SPECIFICATION
 FOR
 TEST REQUIREMENTS
 FOR
 STEADY STATE VIBRATION TESTING
 OF
 ASME SECTION III NUCLEAR CLASS
 1, 2, 3 AND ANSI B31.1 BECHTEL PIPING
 FOR THE
 LIMERICK GENERATING STATION
 UNITS 1 AND 2
 PHILADELPHIA ELECTRIC COMPANY
 POTTSTOWN, PENNSYLVANIA

NO.	DATE	REVISIONS	APPROVALS
	5/25/84	Addition number 2 to Rev 1	<i>[Signature]</i>
	4/15/84	Addition number 1 to Rev 1	<i>[Signature]</i>
1	4/6/84	Revised as noted in sheet 1, ii	<i>[Signature]</i>
		Issued for Use	KBS
0	12/6/83	Issued for Use	<i>[Signature]</i>

Adn. 2
Rev. 1

System : E - HPCI Steam Supply
 Location : Outside Containment
 Isometric : SK-M-1556B Rev. N
 Calculation No.: PI-24-51

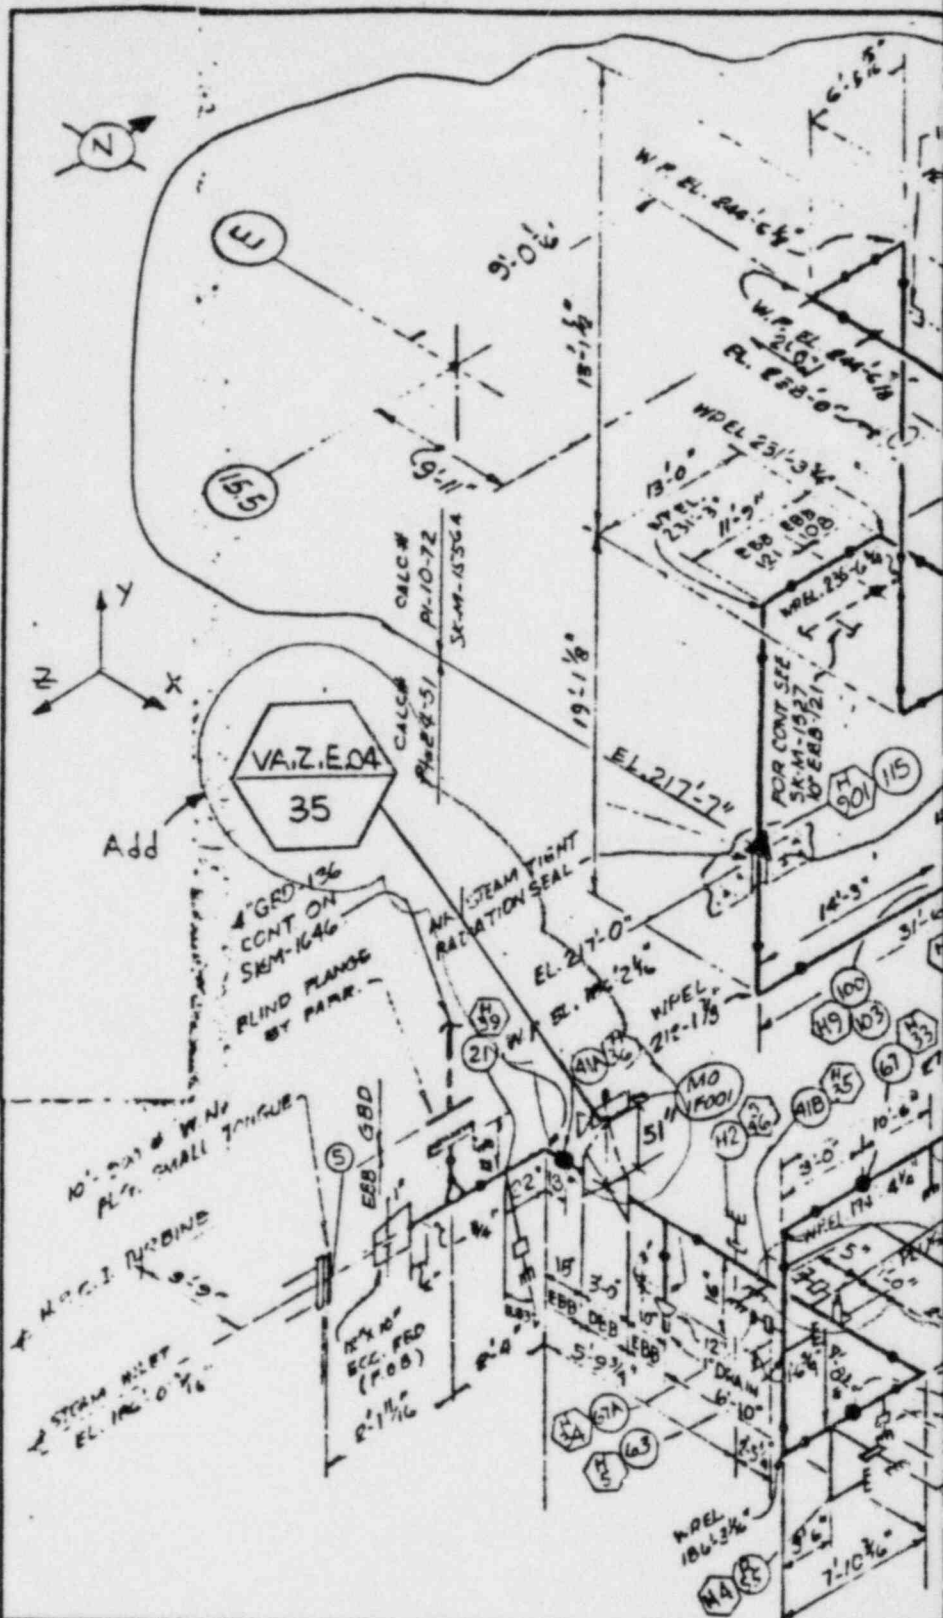
QUANTITY MEASURED	MEASUREMENT			REMARKS	
	METHOD		DATA POINT		AXIS ³
	REMOTE INSTRUMENTATION ¹	VISUAL INSPECTION ²			
Acceleration	later		later	later ← Delete	
Acceleration	VA,Z,E,04		35	Z	Valve operator MO-1F001
Acceleration	VA,Z,E,05		65B	Z	
Acceleration	VA,X,E,06		90E	X

CALC NO: PT-24-51

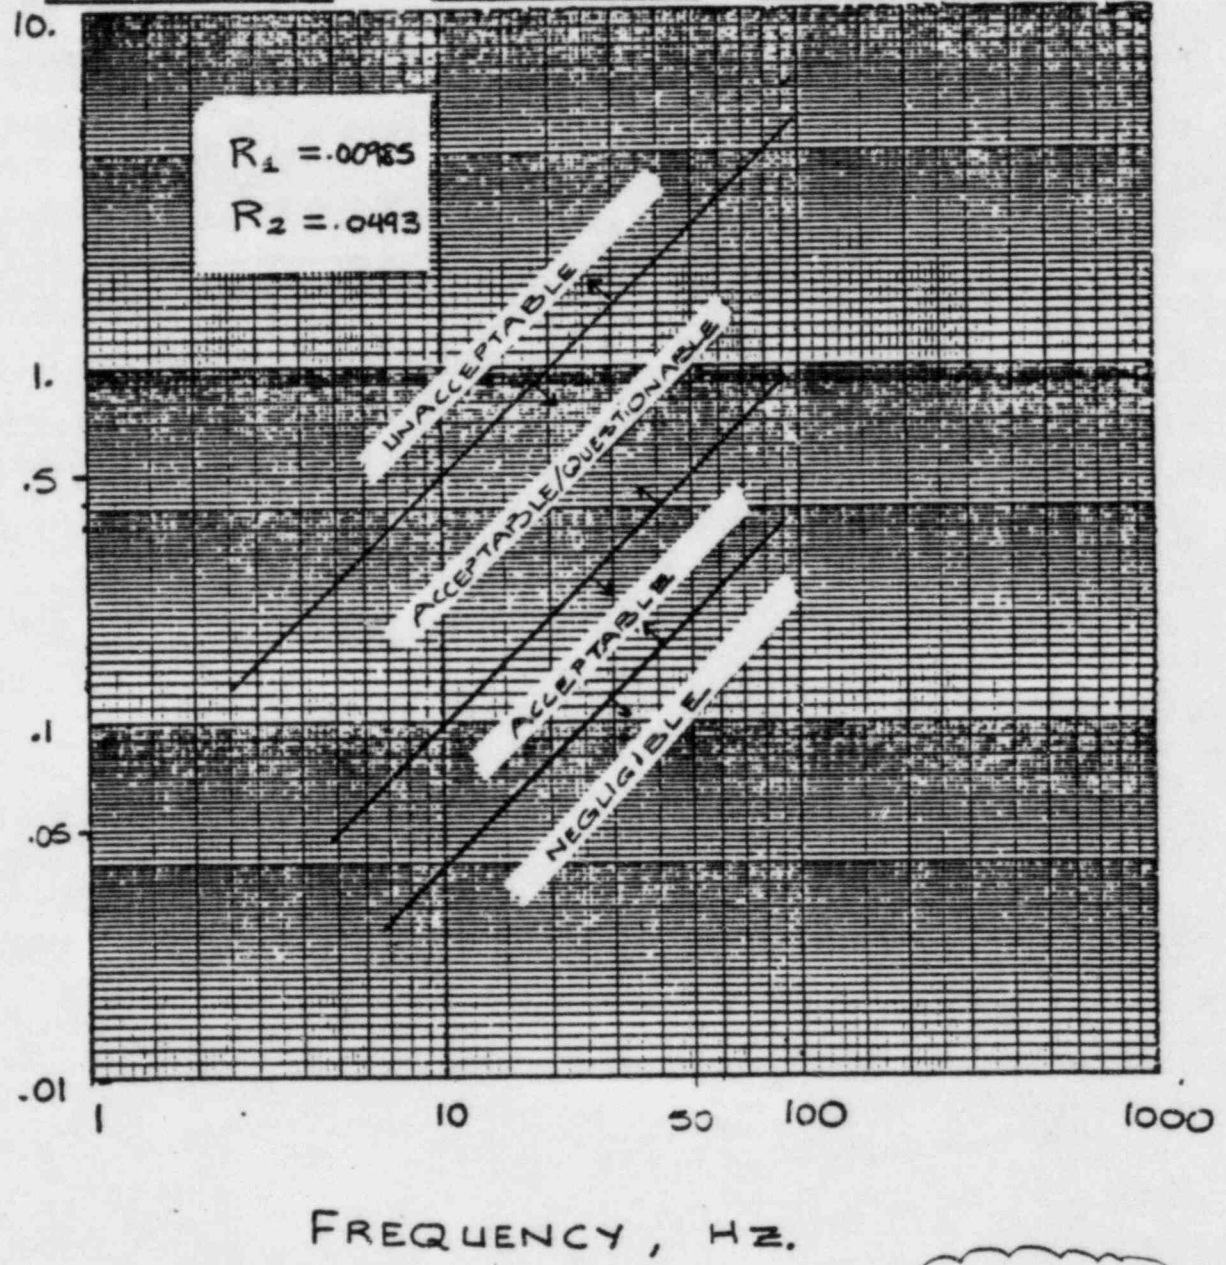
65B-Z

VA.X.E.06

FROM: RPV NOZZLES 15
 TO: FWD HEAD X-14
 CALC NO: H10-11B
 ISO. NO: SK-M-1551 B Rev. M
SK-M-6453 Rev. G
SP-DA-115-EI-Rev. 5

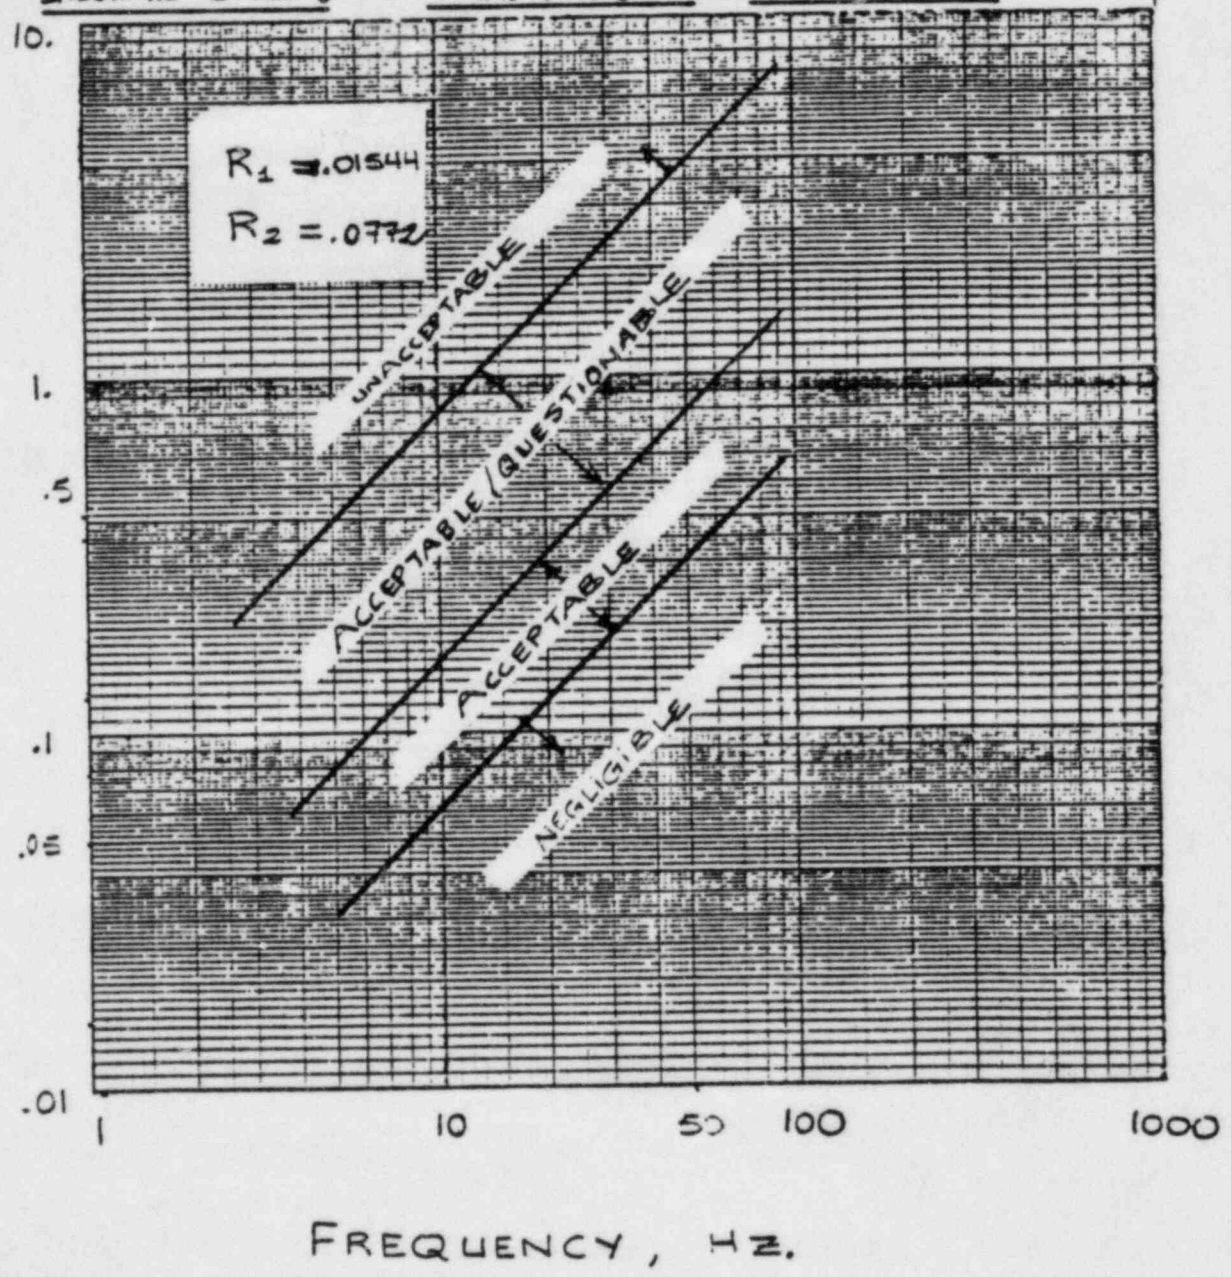
VA. Y. P. 08 Deleted

Instrument No	Data Point	Axis	Remark
VA.Y.P.09	847	Y	Acceptable measured acceleration later see E-23 ↖ change
